GE ENERGY

Subject: Responses to Methods RAIs - Interim Methods LTR

Responses to RAIs Related to NEDE-33173P

Responses to RAIs Related to NEDE-33173P

Figure R2.2-1 Sensitivity of Cold Critical Eigenvalue to EPU Operation

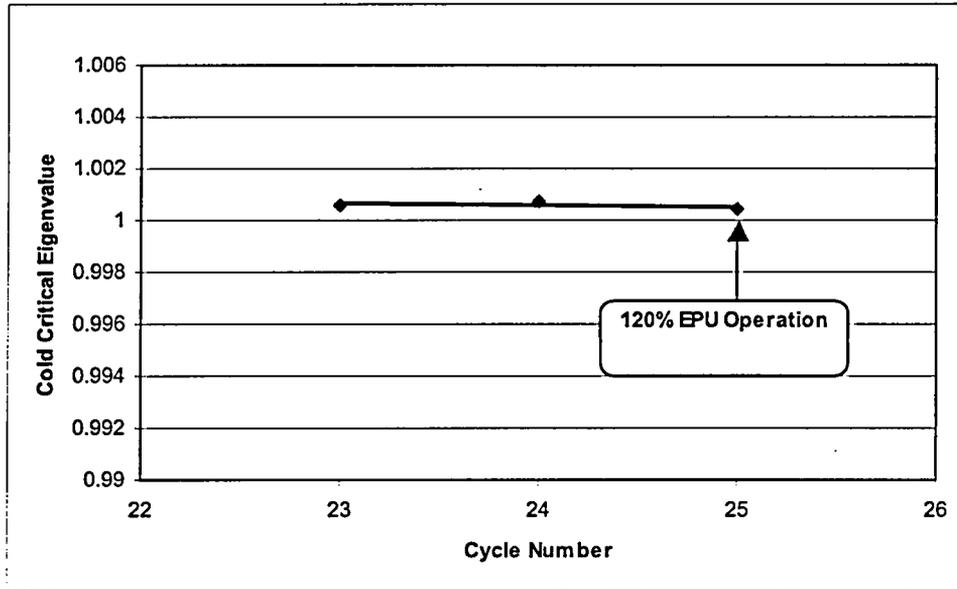
The LTR states that the same SDM Technical Specification value used for non-EPU core designs is adequate for EPU and expanded operating domain conditions. Provide the basis as to why cold SDM is not a strong function of the current operating strategies by comparing cold critical data before and after EPU. Include in the discussion the impact of core designs necessary to achieve EPU and maintain extended cycle lengths (e.g., larger batch fractions, higher bundle enrichments and different core loading patterns).

As a final demonstration of these concepts, the trending of the cold eigenvalues for a BWR/4 through a 120% EPU transition is provided in Figure R2.2-1. The scale of the data is consistent with that given in Figure 2-4 of NEDC-33173P. There is no identifiable aberration with the trend because of EPU.
